## **DESIGN REVIEW COMMITTEE**

## STAFF REPORT AND FINDINGS OF FACT

SUBJECT: DESIGN REVIEW REQUEST (DR19-02) BY WALT POSTLEWAIT TO  
CONSTRUCT 66 UNIT RESIDENTIAL / TRANSIENT LODGING MIXED USE  
IN FOUR BUILDINGS AT 461 32ND STREET

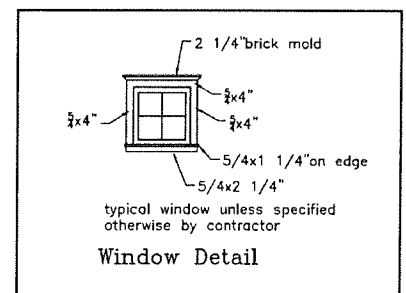
Finding: Proposed windows are single and paired, one over one, rectangular, clear glass, with 5/4 x 4" casing. Windows in the upper half monitor area and some on the side elevations are square. All elevations have multiple windows and there are no large expanses of blank walls.

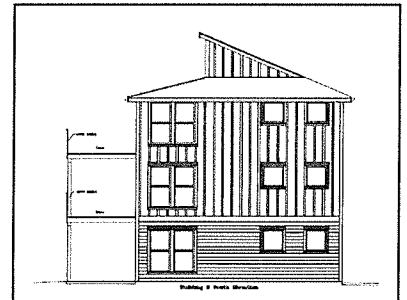
Finding: The structures are proposed to be sided with a mixture of horizontal siding on the first floor with 5” to 6” reveal. Upper floors are proposed to be board and batten with 1x3 battens. All siding would be smooth fiber cement siding. No faux texturing is proposed.

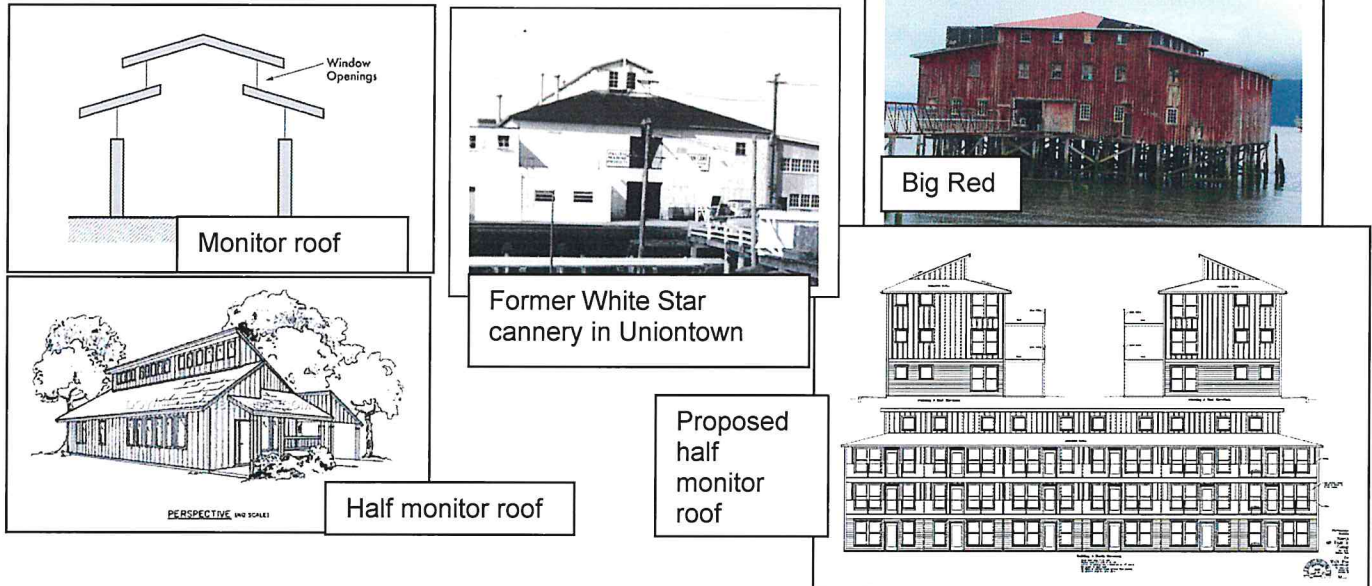
Finding: The structure will have a hip roof with a half monitor roof. A “monitor” roof generally has two sides with windows and sits along the ridge of a pitched roof. A half monitor roof has a roof pitch that extends from the main roof and has windows on one side only. Monitor roofs are similar to clerestory roofs which were both common on waterfront buildings in Astoria. Prior to the storm of 2007 which destroyed the upper floor, Big Red (historic net loft adjacent to the proposed site), had a wide monitor roof.

The hip roof would have a 4:12 pitch and the half monitor roof would have a 5:12 pitch.

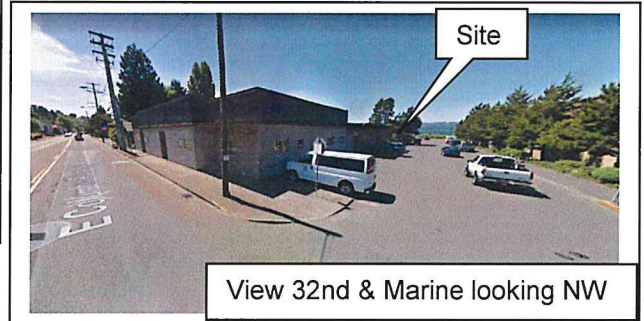
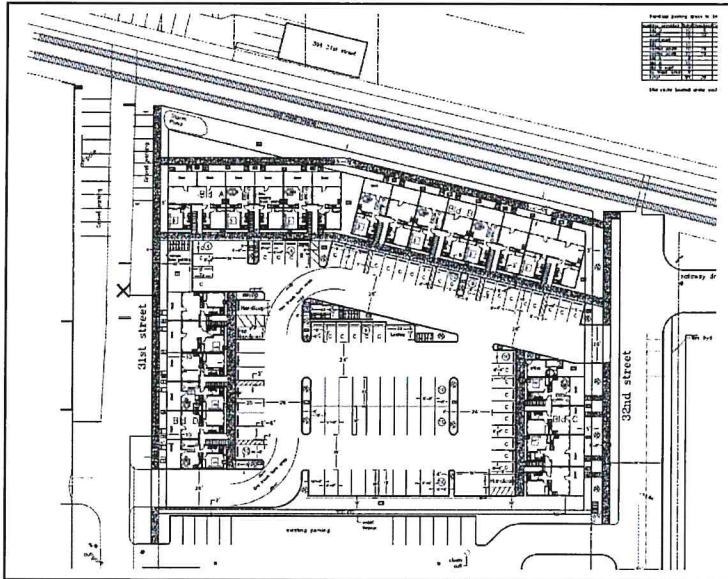
Finding: The proposed project covers approximately the north half of the block between 31st and 32nd Streets. The project has frontage on these two rights-of-way and on the River Trail to the north. The main facades are proposed to face the right-of-way and Trail. The parking area is in a central area surrounded by the buildings and is not visible from the Marine Drive right-of-way. The buildings are pedestrian-oriented and connect to the sidewalks and Trail.

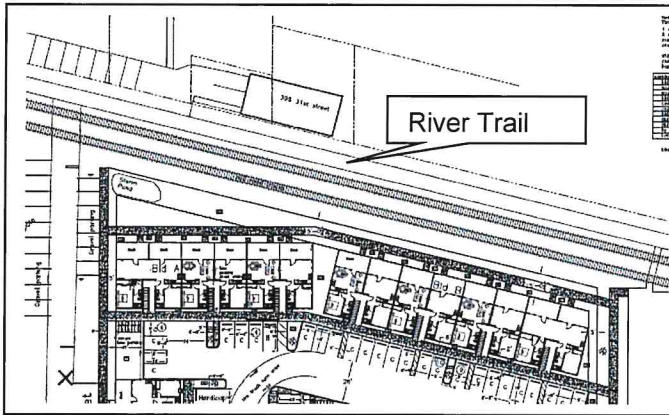
Finding: As noted above, the size of the proposed buildings is in scale with the adjacent neighborhood. The Columbia Landing buildings and 396 31st Street are three stories tall. Big Red is taller at approximately 35' to 40' with a ridge height of approximately 50' above the level of the water, and is much larger but is located approximately 300' from shore which reduces the impact of its size. The proposed structure would be 32' tall (three stories). The buildings would have horizontal siding on first floor and vertical board and batten on the upper floors in smooth fiber cement siding. Big Reg and 396 31st are board and batten; Columbia Landing is horizontal fiber cement siding; and Safeway is brick. The proposed materials are compatible with the character of the waterfront in this area.

The buildings are proposed to be a minimum of 15' from the north property line to the facade of the building including decks/porches at its closest point. Building B will be parallel to the north property line, but Building A will be angled to the south on its west side to create a change in the plane of the two buildings to help reduce the impact of the two structures. The buildings will be separated by approximately 5' to 10' depending on the angle. The River Trail in this area is close to the north portion of the City property and would be approximately 52' from the closest portion of the building. This would also reduce the impact of the buildings on the River Trail. Columbia Landing structures are approximately 31' from the River Trail and the 31st Street building is approximately 8' from the River trail. The north side of the proposed buildings would include a pedestrian walkway and landscaping to buffer the buildings from the Trail.

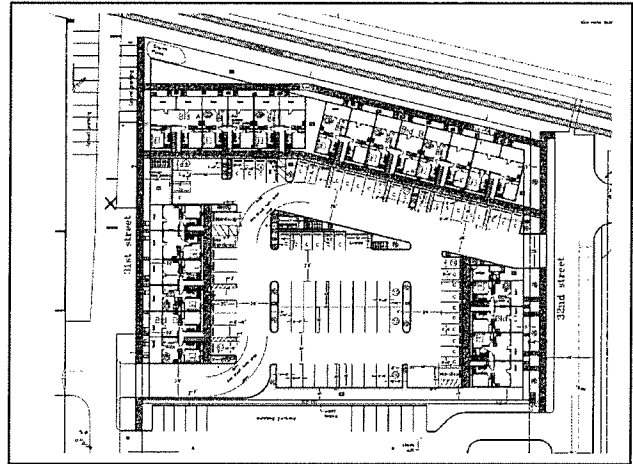
Finding: The proposed buildings along 31st and 32nd Street are set back 5' from the property line. No structural encroachments shall be allowed in this area other than the steps to the sidewalk.
